TULSA METROPOLITAN AREA PLANNING COMMISSION

For Meeting No. 2488

August 1, 2007

PRELIMINARY PLAT

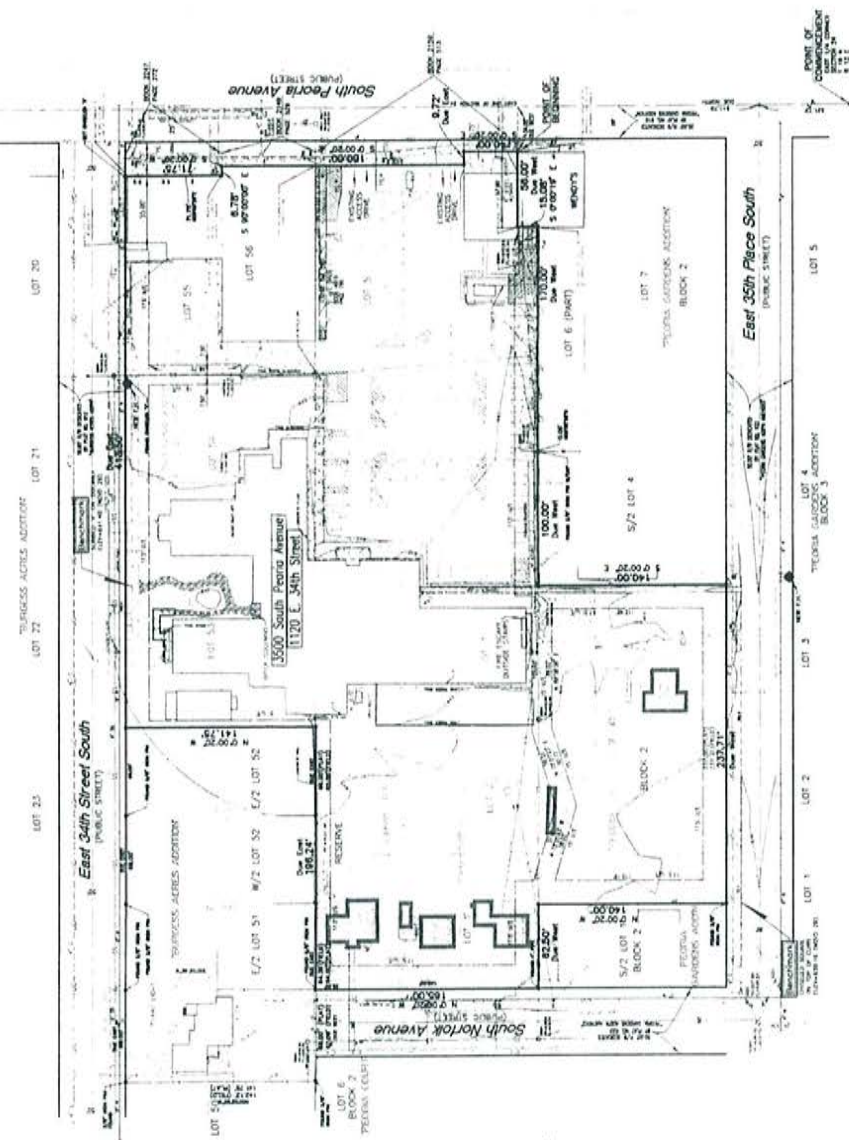
GIS: Provide surveyor's e-mail address. Add surrounding subdivision names to key map. Show basis of bearing on face of plat.

General: Label plat as Lot 1, Block 1 and delete previous lot and block numbers reserves. Detailed information should be removed from the face of plat when not pertaining to platting requirements. Location map needs to show all plat names in the section shown. On the draft final plat basis of bearing and monumentation are needed. Please revise the legend to include the symbols and abbreviations that will appear on the face of Plat, such as those for easements and rights-of-way.

LANGSTON UNIVERSITY 2

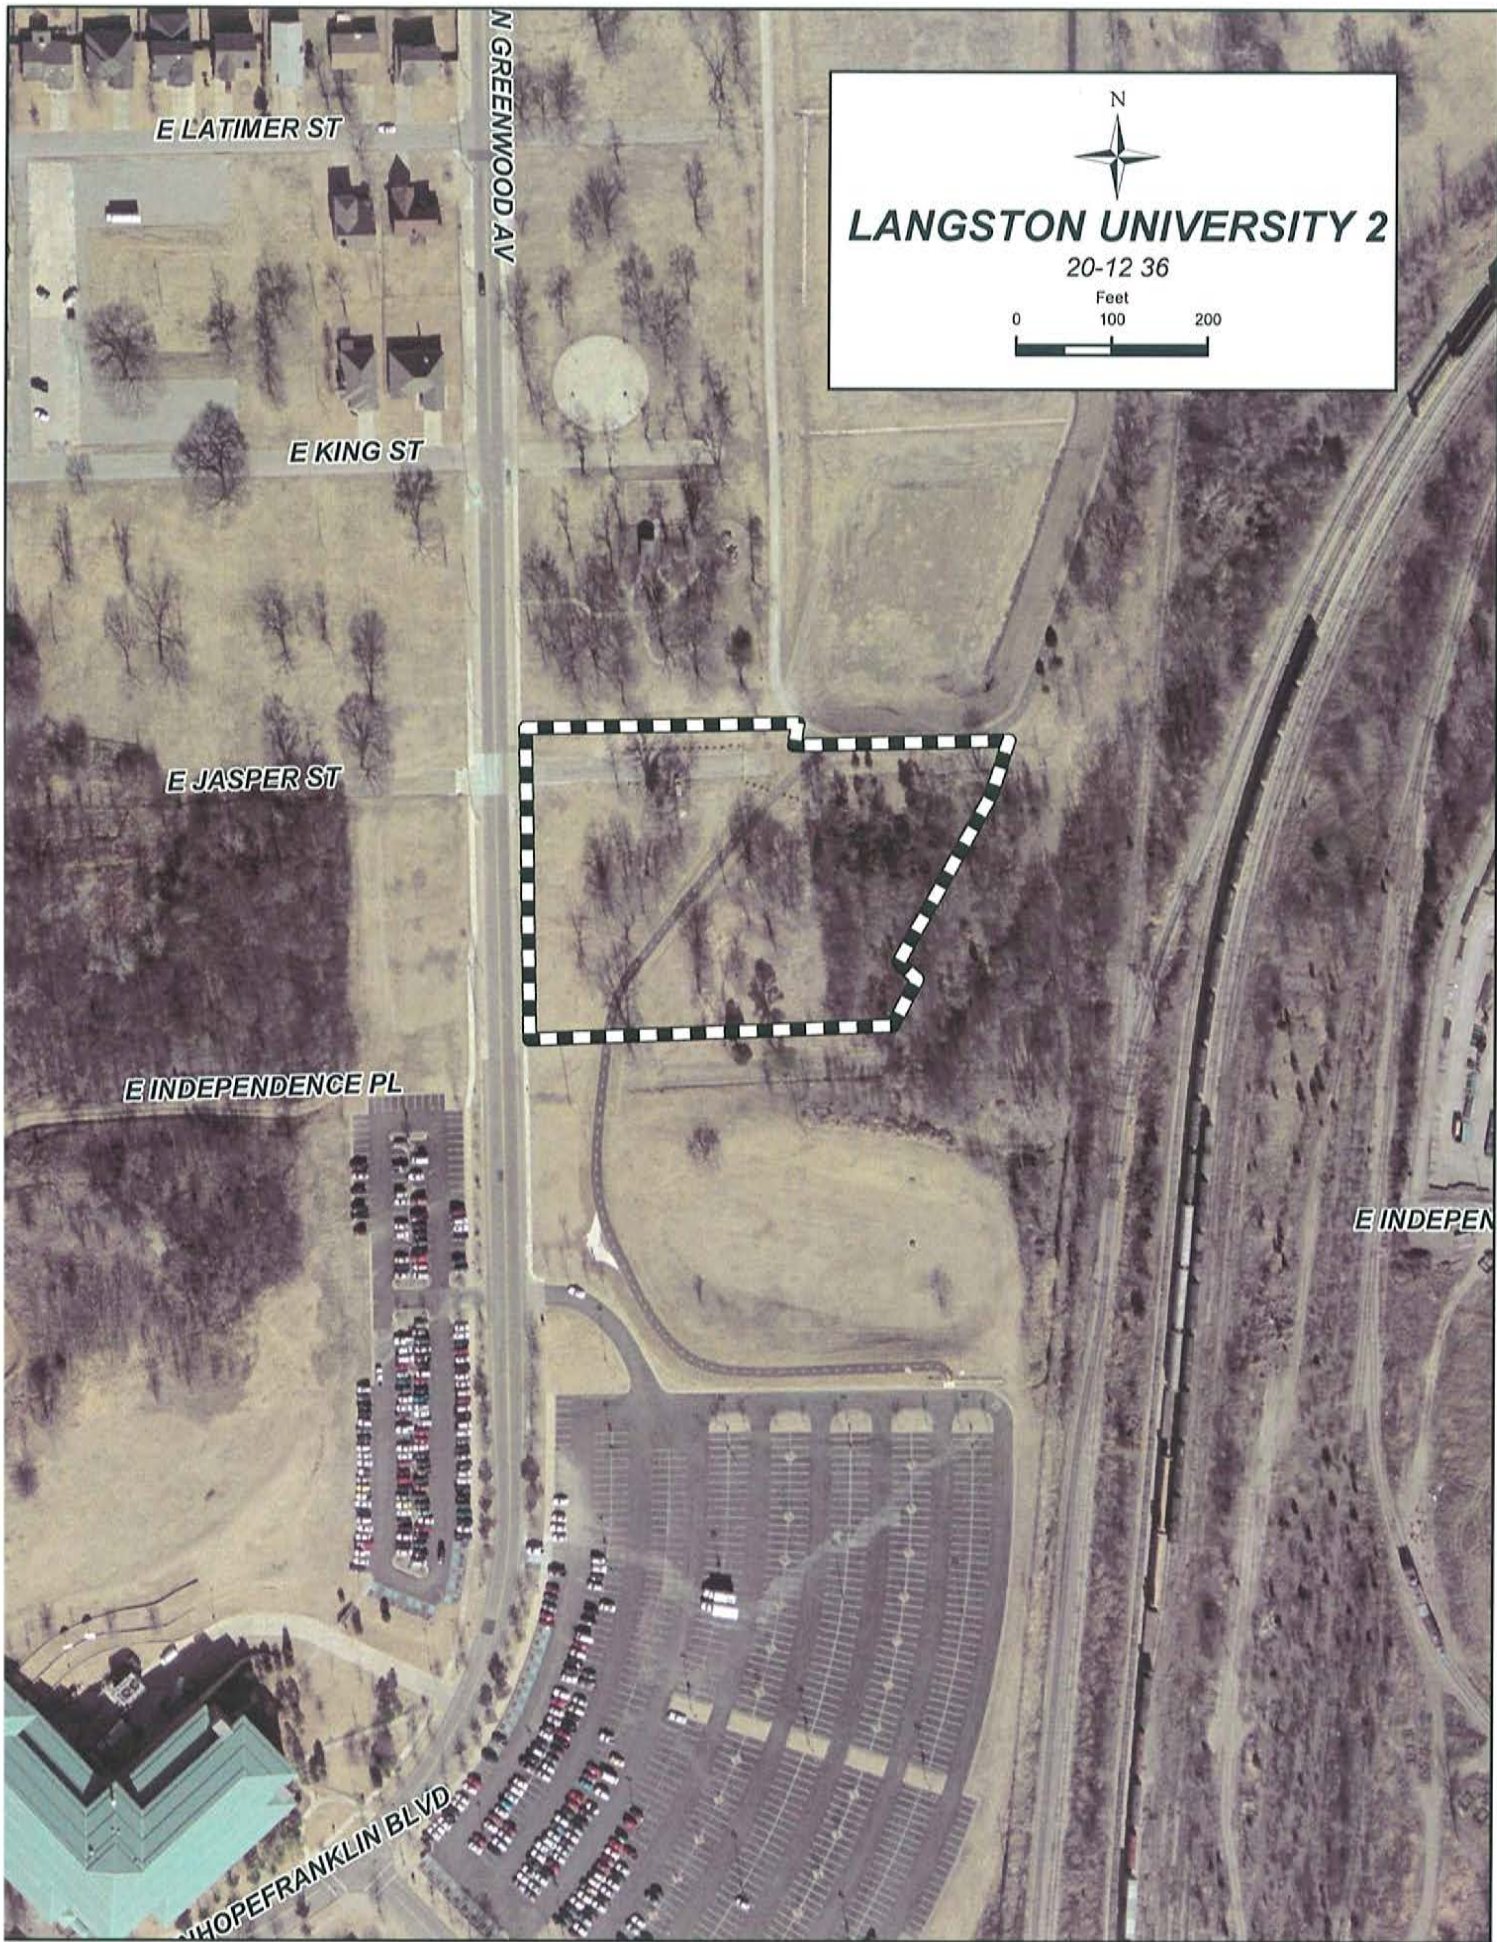
1. **Zoning:** The property is zoned OM, IL, CH with BOA case 20372. Trail relocation must be acceptable to transportation trail planner and public works staff. Trail location must be shown on face of plat. Language acceptable to City Legal must be put in deed of dedication/covenants. Show trail as Osage Prairie Trail north of City Limits and as Osage Trail inside the City Limits. Clarify who will relocate trail.

2. **Streets:** Document the existing Greenwood right-of-way. Label the adjacent property to the east (assumed as expressway right-of-way). Show Limits of No Access along any actual expressway right-of-way.

3. **Sewer:** Add a 17.5 foot perimeter easement for the entire platted area. The sanitary sewer easement referred to in the covenants could not be found on the face of the plat. A sanitary sewer mainline extension is required to provide sanitary sewer service to the platted area. The proposed line must be added to the conceptual plan.

4. **Water:** Include standard waterline language. Show the existing water main along the east side of Greenwood Avenue.
5. **Storm Drainage:** All public drainage must be conveyed in an easement. It may be necessary to plat storm sewer and overland drainage easements (ODE). Please add a note stating where the stormwater detention for this site has been provided. If ODEs are added to the plat, then please add their standard language to the covenants. Please add the standard language for surface drainage, and all other required standard language.

GIS: Provide surveyor's e-mail address and add date of preparation. Include a tie from a section corner with the point of commencement to the point of beginning with the metes and bounds description of the property in the legal description.

General: Beneath the heading please include as a part of the tract's general description, that portion that is a re-subdivision of existing subdivisions. Please add the abbreviations for right-of-way and utility easement to the legend, and any other abbreviations being used. Include standard deed of dedication language including the legal (transferred from the face of the

Corridor Site Plan
169 Business Park
A Resubdivision of
Lots Five (5), Six (6), Seven (7), Eight (8), Nine (9) and Ten (10), Block Six (6),
UNION GARDENS an Addition to the City of Tulsa, Tulsa County, State of Oklahoma

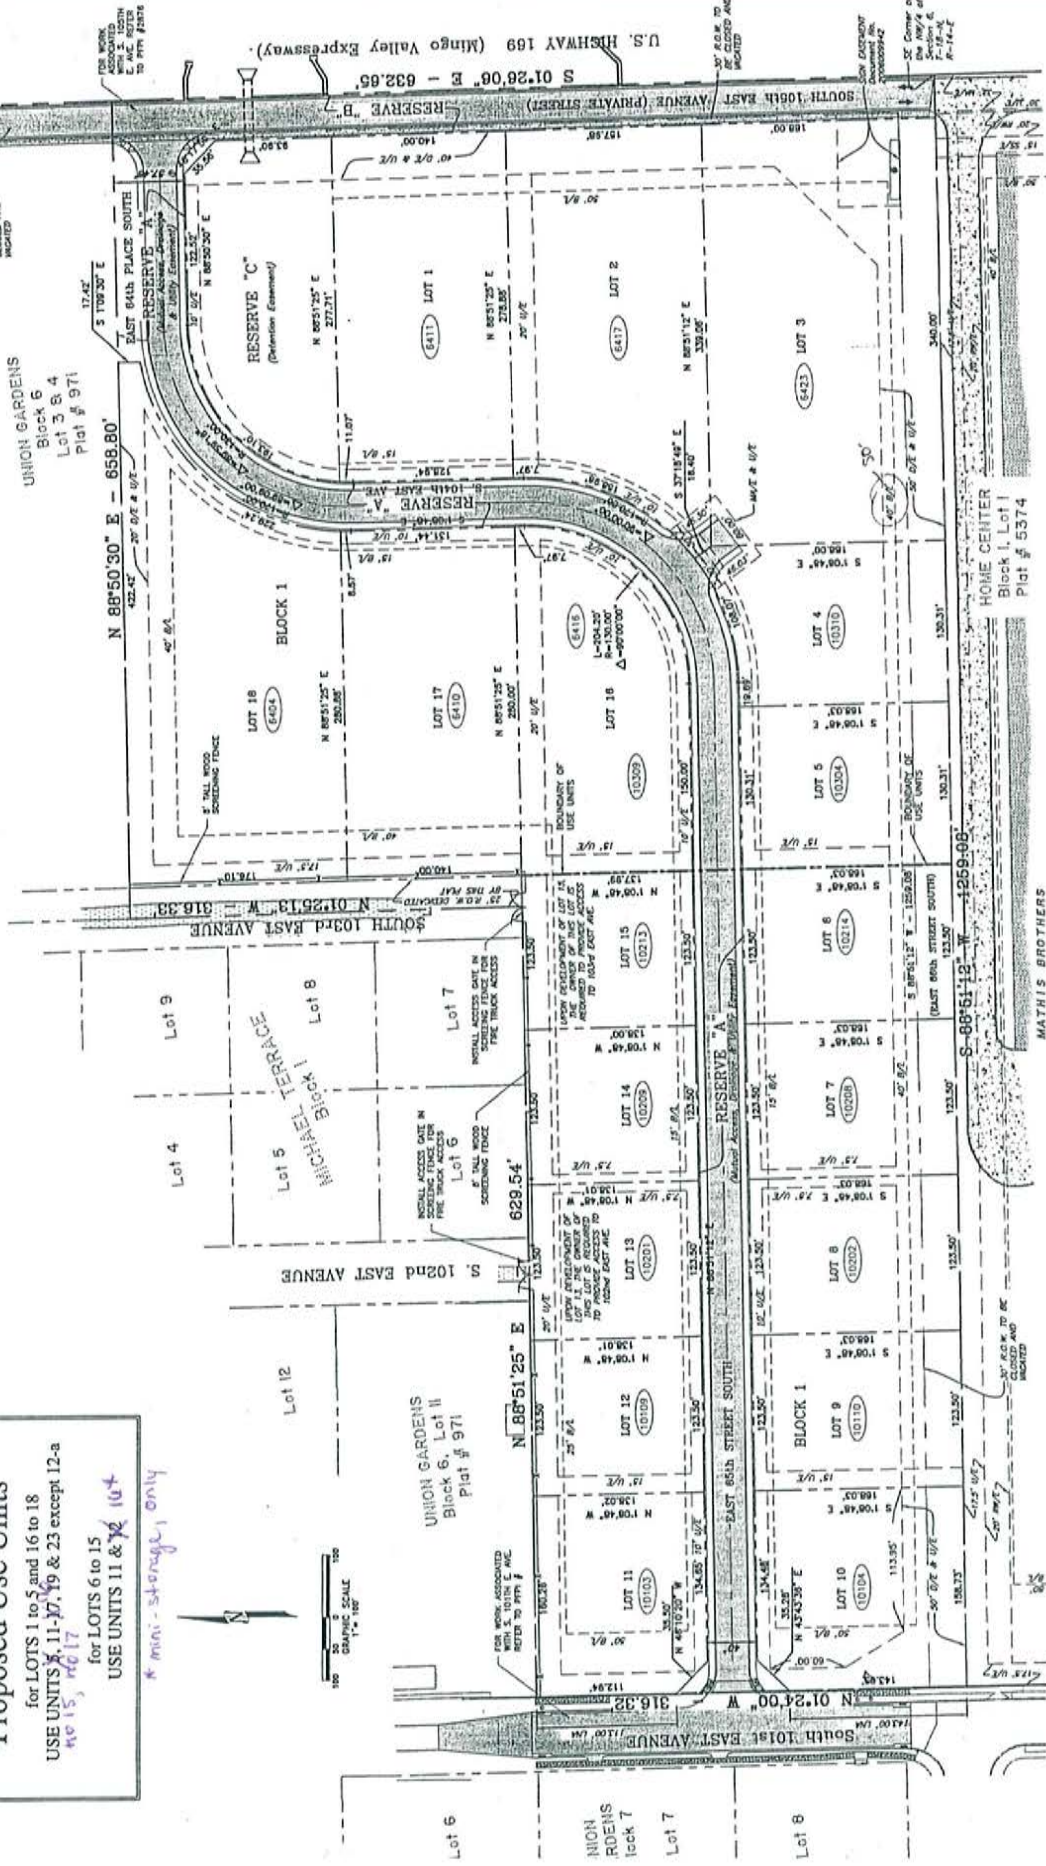
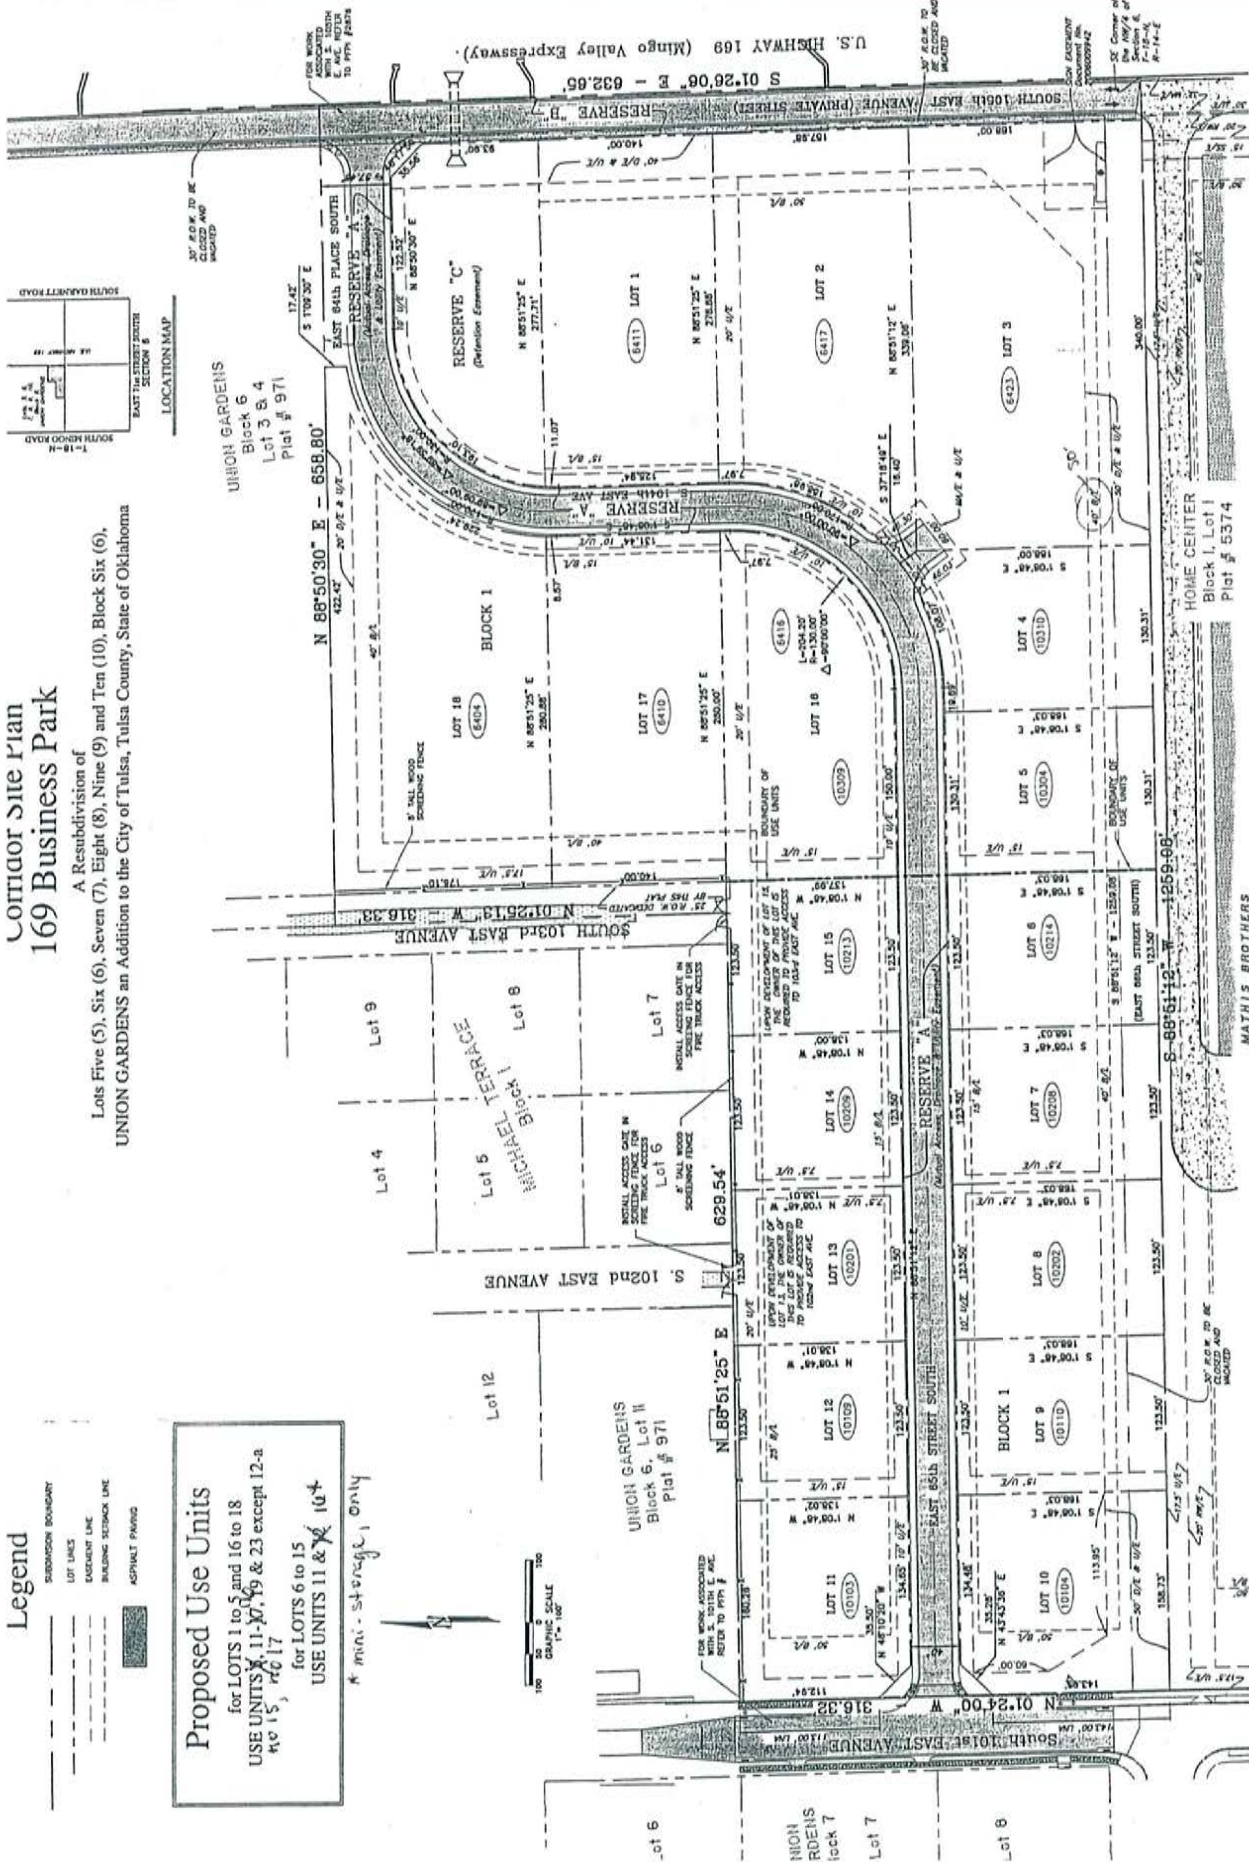
General: Site Plan differs from PFPI #2876 with regard to number and sizes of lots.

Fire: Provide mutual access easement through Lots 13 and 15 for emergency fire department access to 102nd and 103rd East Avenue. (Per Fire Marshall approval and dedication per separate easement.)

PSO: Separate drainage and utility easements; Designate landscape easement within or adjacent to utility easement so utilities can avoid locating in planting areas (trees).

Mr. Blind requested the following changes on the building setbacks: From north property line of Lot 10, Block 6, Union Gardens, Lots 11-15, Block 1 of 169 Business Park be 25 FT as shown on the submitted plan. The suggested 40 FT by staff encroaches into the lots and makes them difficult to build on. The northwest portion of the subject property becomes thin. He indicated that he is

Mr. Blind continued that on screening and landscaping he is in agreement with staff's recommendation. He stated that he has shown an eight-foot tall screening fence along the northern property line and the western property line where the residential areas are located. However, he did not show an eight-foot screening fence along the northernmost property line because that property is currently being marketed for a commercial use. He requested that this be amended.

Mr. Midget asked staff about the amended setbacks. In response, Ms. Matthews stated that staff would agree with the setback amendments and would agree with everything that Mr. Blind has requested today.

On **MOTION** of **MIDGET**, TMAPC voted **6-0-0** (Ard, Bayles, Cantees, Collins, Midget, Wofford "aye"; no "nays"; none "abstaining"; Bernard, Carnes Harmon, Jackson, "absent") to recommend **APPROVAL** of the corridor site plan for Z-6277-SP-3/Z-6484-SP-1/Z-6718-SP-1 per staff recommendation as amended by the applicant. (Language with a strike-through has been deleted and language with an underline has been added.)
